Going-to-the-Sun Road
Identified Roadway Deficiencies - 2001

Going-to-the-Sun Road
Identified Roadway Deficiencies - 2001
Alpine Section
Alder Creek Segment - Map 1 of 3
Guard Walls:
ashlar stone
concrete-core
jersey barrier
removable rail
random rubble stone
mixed stone
Retaining Walls:
concrete
stone
Other Linear Features:
barrier rock
curb
post and rail fence
CMP culvert with stone headwall
concrete-box cross-road drains with metal grate inlet
CMP culvert
CMP culvert with stone headwall
CMP culvert with modern drop box inlet
CMP culvert with stone headwall
CMP culvert with stone headwall
drop inlet covered with boards
FHWA wall 25.01
FHWA wall 25.29
FHWA wall 25.32
FHWA wall 25.33
FHWA wall 25.34
FHWA wall 25.36
FHWA wall 22.82
pullout
pullout
pullout
MP 23.0
MP 23.1
MP 25.3
MP 25.4
MP 25.5
MP 25.6
MP 25.7
919
917
916
915
914
913
912
911
910
909
908
906
905
904
903
MP 25.3 - 25.5:

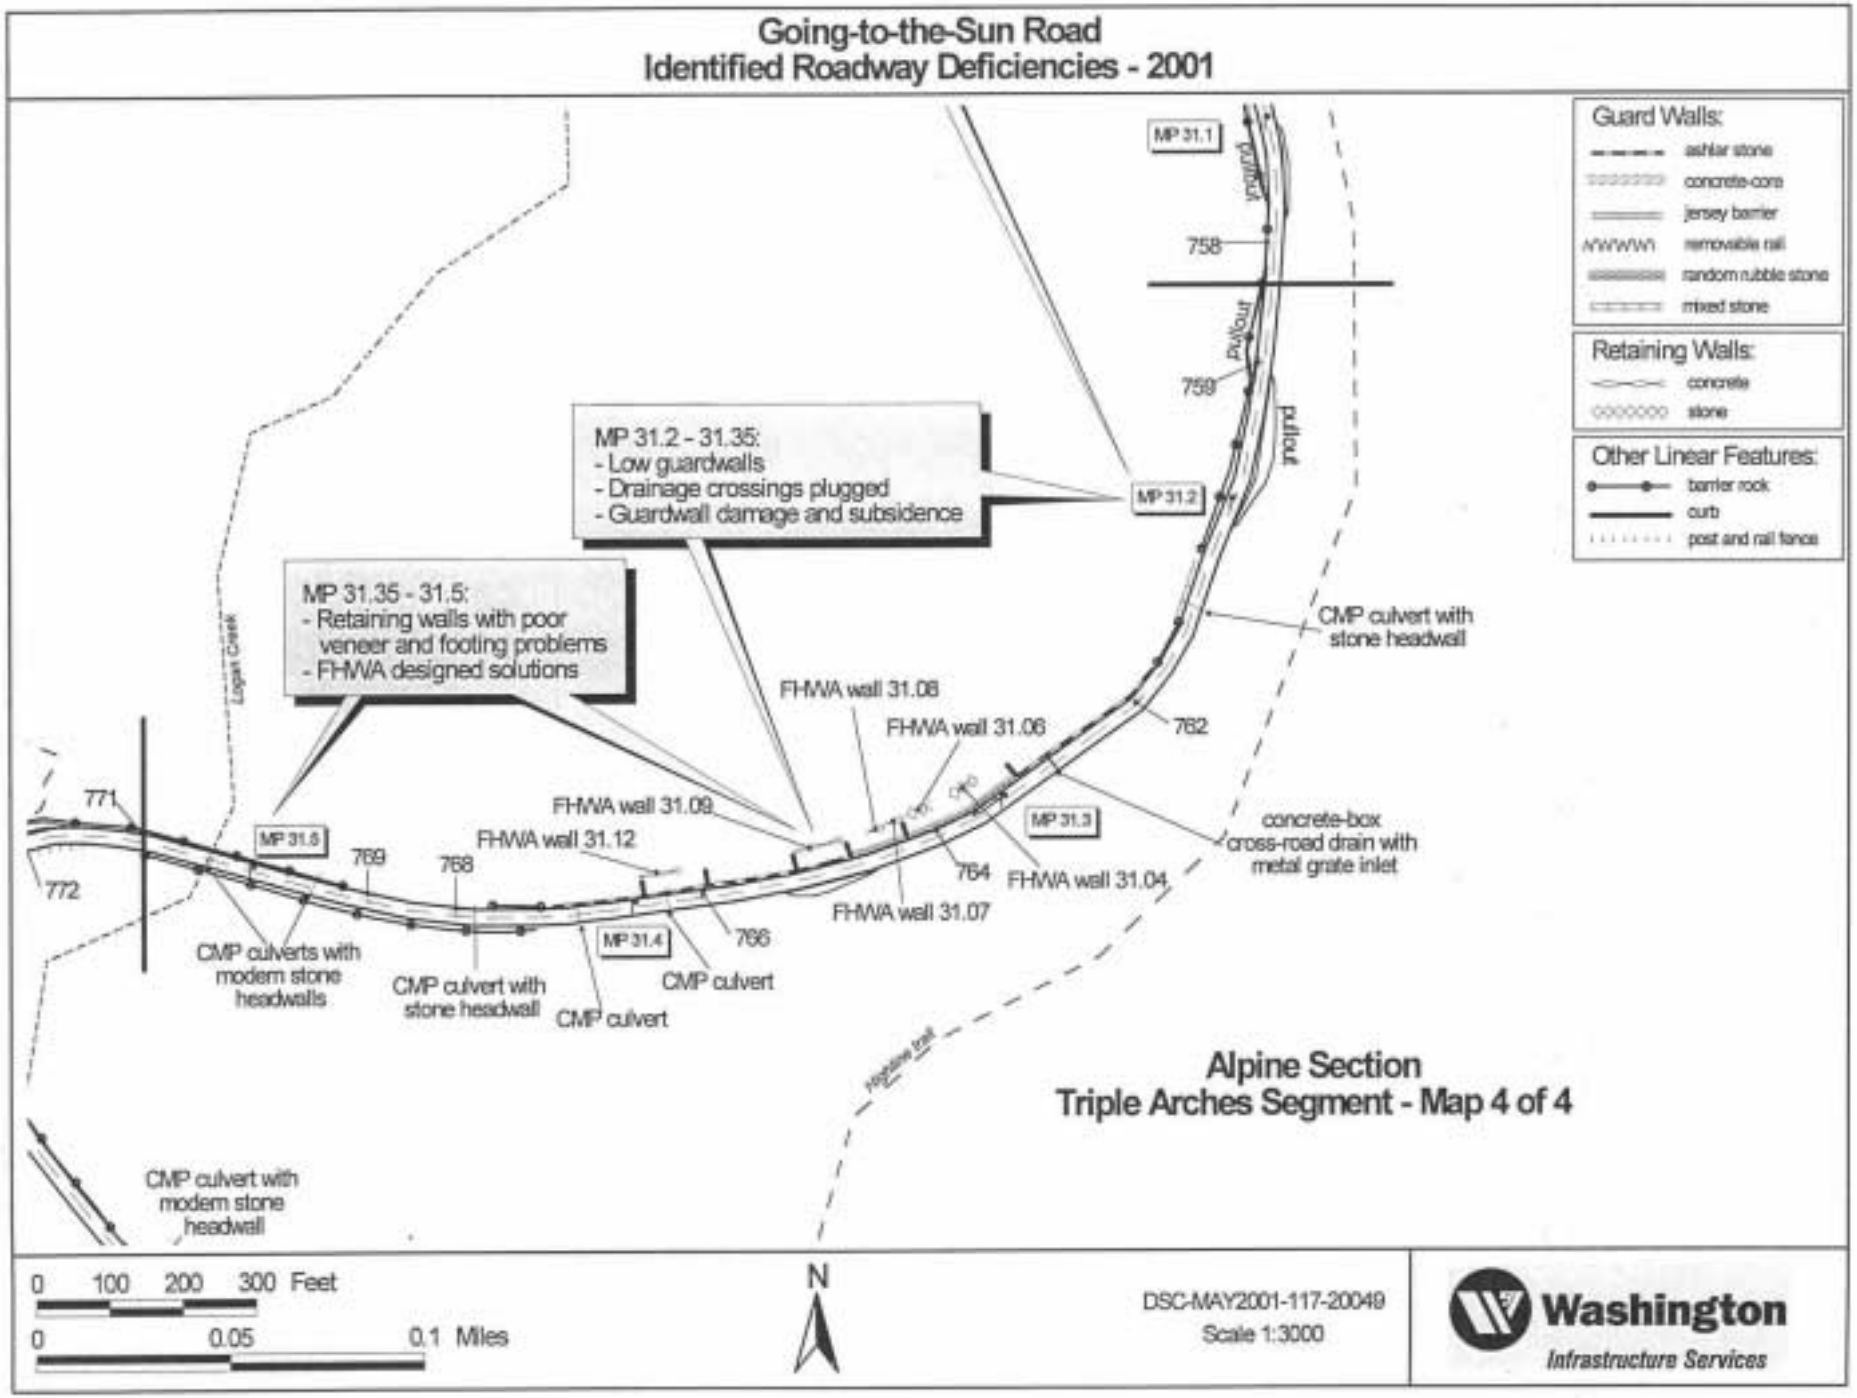
- Low guardwalls
- Drainage crossings plugged
- Guardwall damage and subsidence
MP 31.35 - 31.5:
- Retaining walls with poor veneer and footing problems
- FHWA designed solutions
Logan Creek
CMP culvert with stone headwall
762
FHWA wall 31.08
FHWA wall 31.06
FHWA wall 31.09
FHWA wall 31.12
MP 31.3
concrete-box cross-road drain with metal grate inlet
764
FHWA wall 31.04
FHWA wall 31.07
771
772
MP 31.5
769
768
MP 31.4
766
CMP culverts with modern stone headwalls
CMP culvert with stone headwall
CMP culvert
CMP culvert
Alpine Section
Triple Arches Segment - Map 4 of 4
CMP culvert with modern stone headwall
0 100 200 300 Feet
0 0.05 0.1 Miles
N
DSC-MAY2001-117-20049
Scale 1:3000
Washington
Infrastructure Services

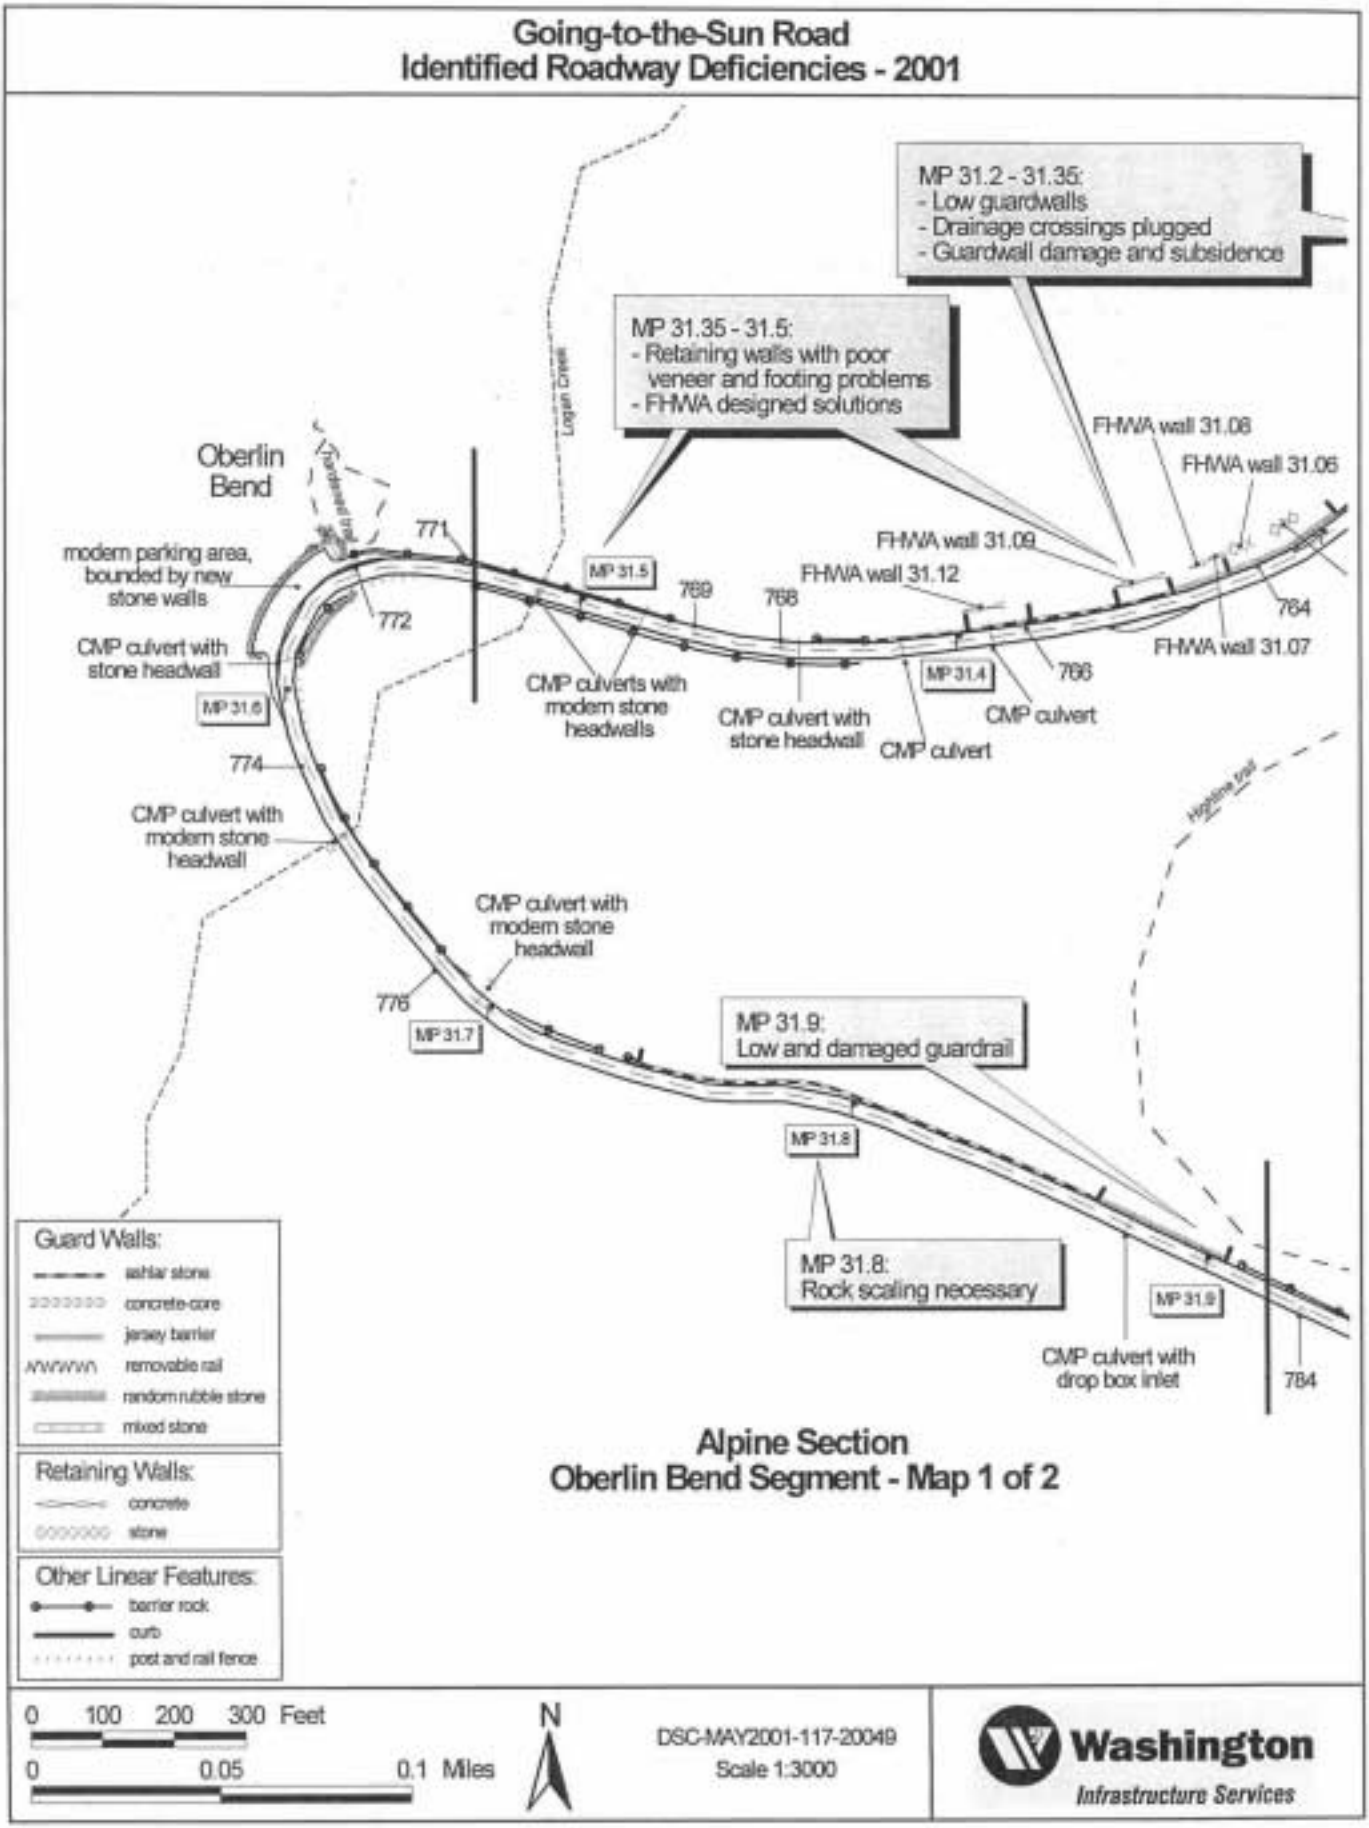
Going-to-the-Sun Road
Identified Roadway Deficiencies - 2001
MP 31.2 - 31.35:
- Low guardwalls
- Drainage crossings plugged
- Guardwall damage and subsidence
MP 31.35 - 31.5:

- Retaining walls with poor veneer and footing problems
- FHWA designed solutions
Logan Creek
Oberlin Bend
Handwood trail
FHWA wall 31.08
FHWA wall 31.06
FHWA wall 31.09
FHWA wall 31.12
FHWA wall 31.07
771
772
774
776
769
768
766
764
MP 31.5
MP 31.4
MP 31.6
MP 31.7
MP 31.8
MP 31.9
modern parking area, bounded by new stone walls
CMP culvert with stone headwall
CMP culverts with modern stone headwalls
CMP culvert with stone headwall
CMP culvert
CMP culvert
CMP culvert with modern stone headwall
CMP culvert with modern stone headwall
Highline trail
MP 31.9:
Low and damaged guardrail
MP 31.8:
Rock scaling necessary
CMP culvert with drop box inlet
784
Guard Walls:
ashlar stone
concrete-core
jersey barrier
removable rail
random rubble stone
mixed stone
Retaining Walls:
concrete
stone
Other Linear Features:
barrier rock
curb
post and rail fence
Alpine Section
Oberlin Bend Segment - Map 1 of 2
0 100 200 300 Feet
0 0.05 0.1 Miles
N
DSC-MAY2001-117-20049
Scale 1:3000

Alpine Section
East Tunnel Segment - Map 2 of 3

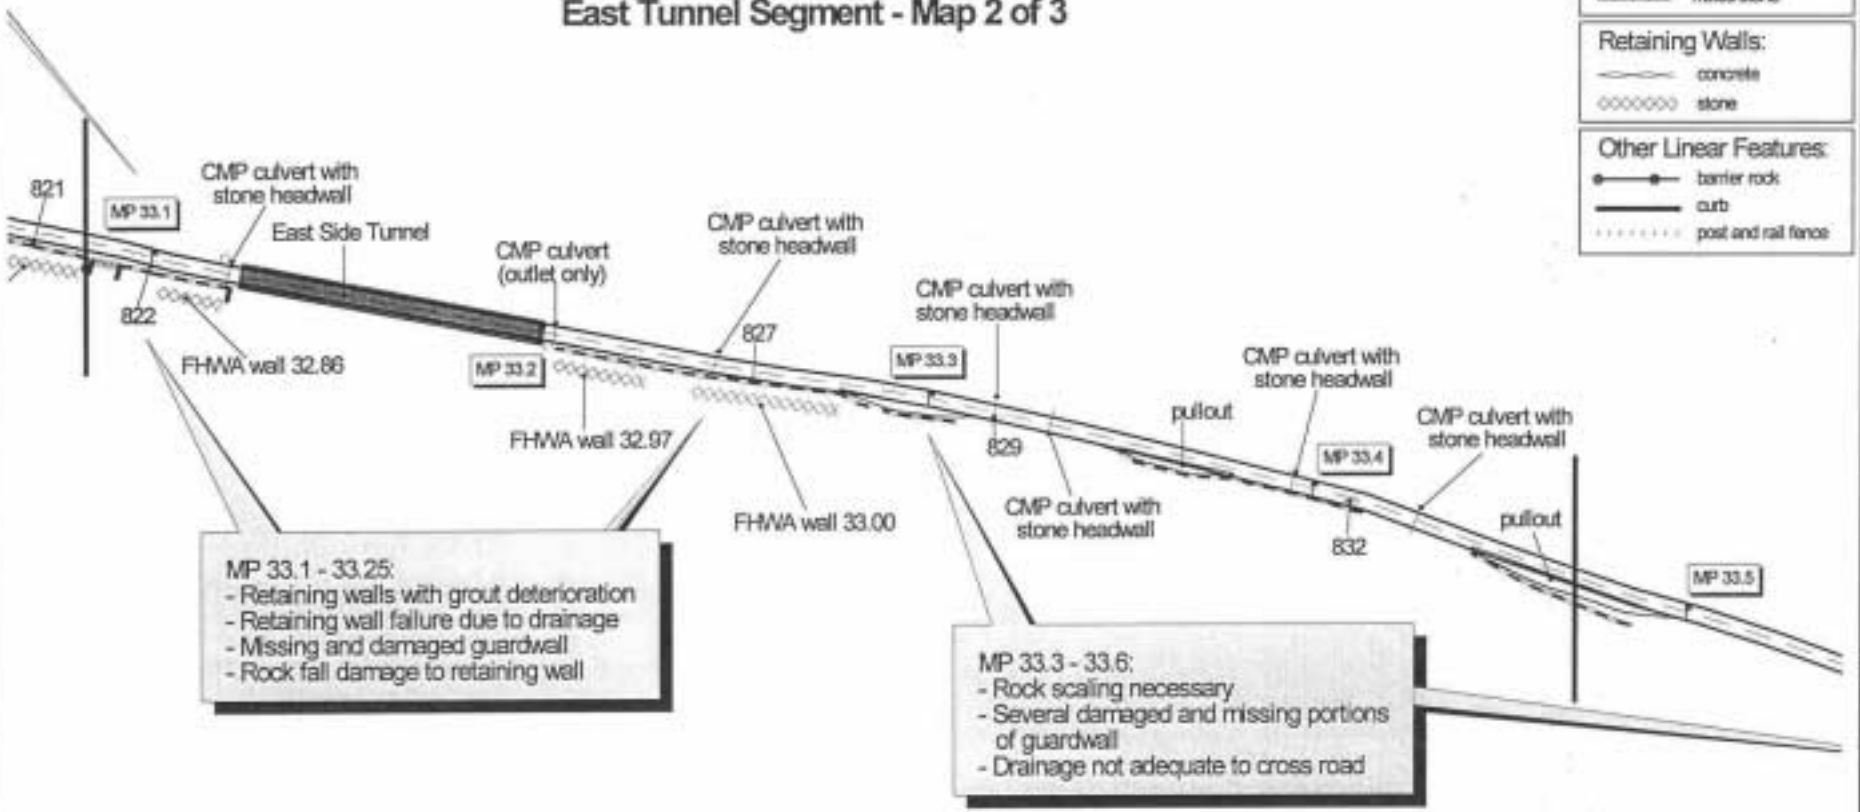
MP 33.1 - 33.25:
- Retaining walls with grout deterioration
- Retaining wall failure due to drainage
- Missing and damaged guardwall
- Rock fall damage to retaining wall

MP 33.3 - 33.6:
- Rock scaling necessary
- Several damaged and missing portions of guardwall
- Drainage not adequate to cross road
